## REPORT TO COMMON COUNCIL

**Item:** Final Plat – North Edgewood Estates 2

The North Edgewood Estates 2 Final Plat, as shown on the attached maps, **BE APPROVED** subject to the following conditions:

# Easement Exhibit

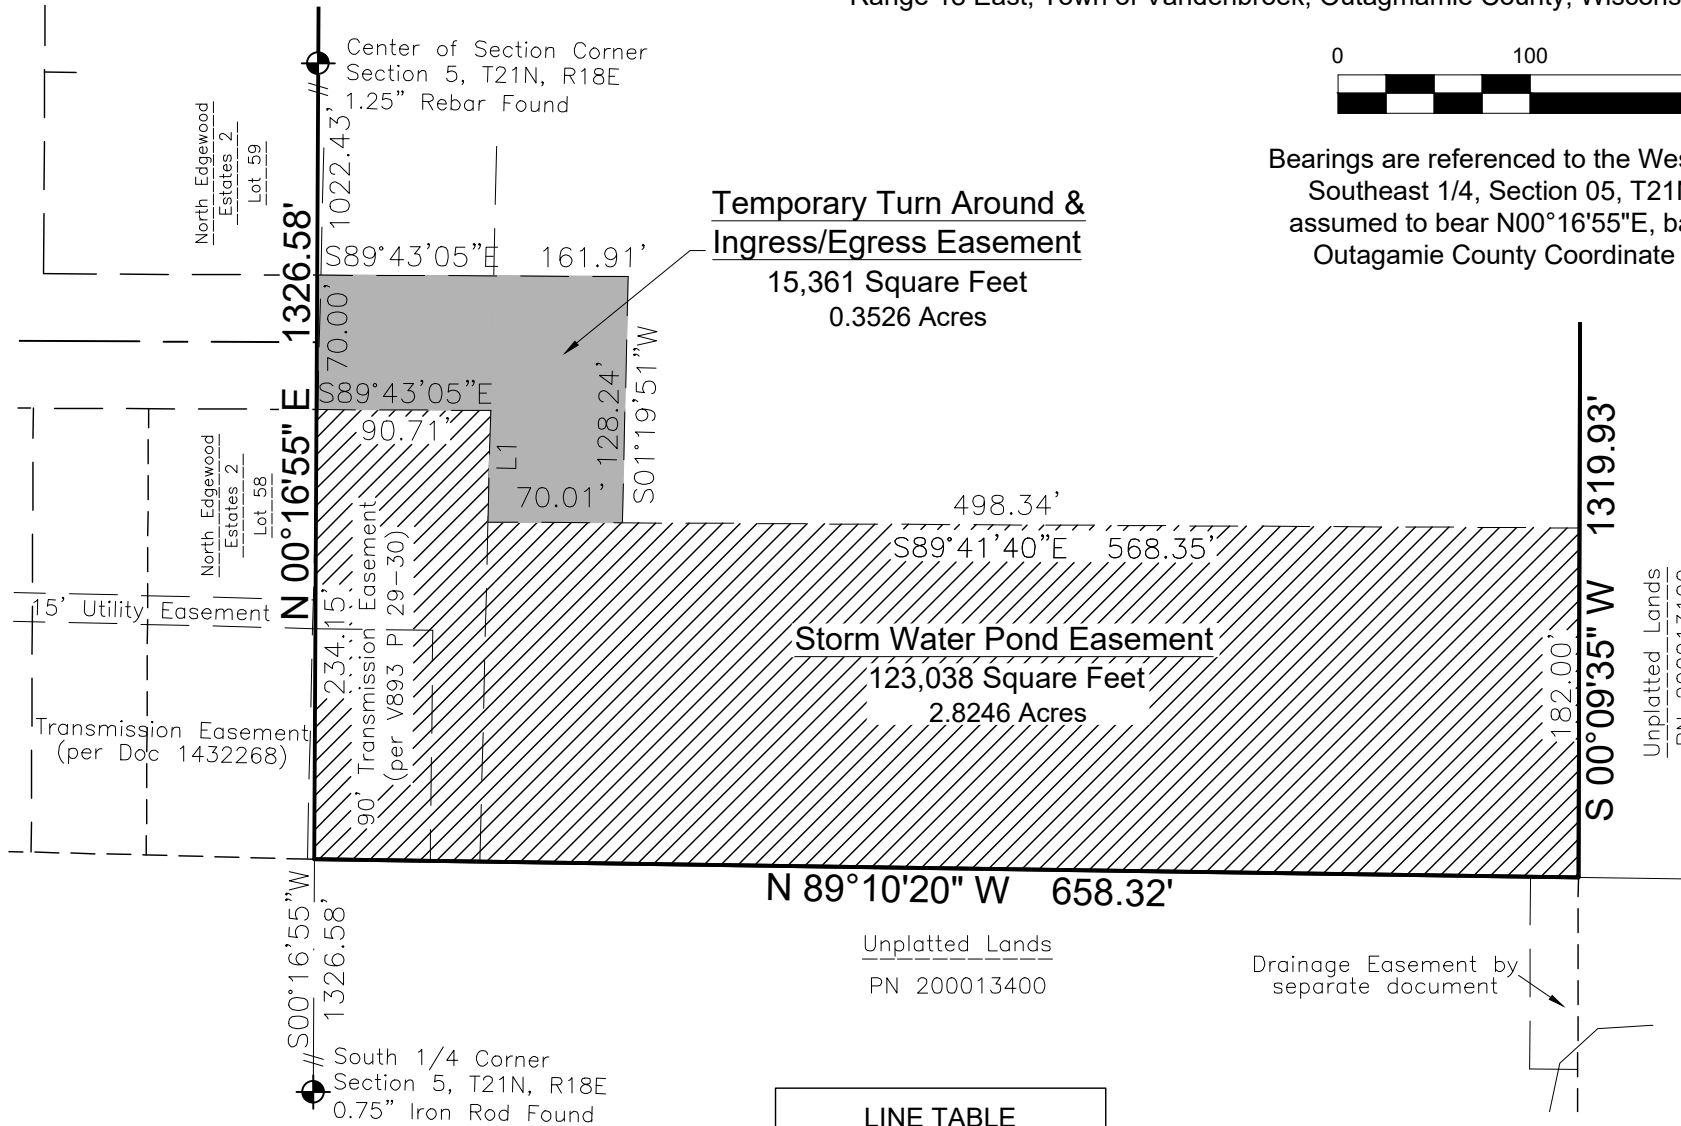
8. The Easement Exhibit terminology “Temporary Turn Around & Ingress/Egress Easement” would be clearer to simply read “Ingress/Egress Easement”. This will need to be a permanent easement unless the landowner dedicates public right-of-way in the future.
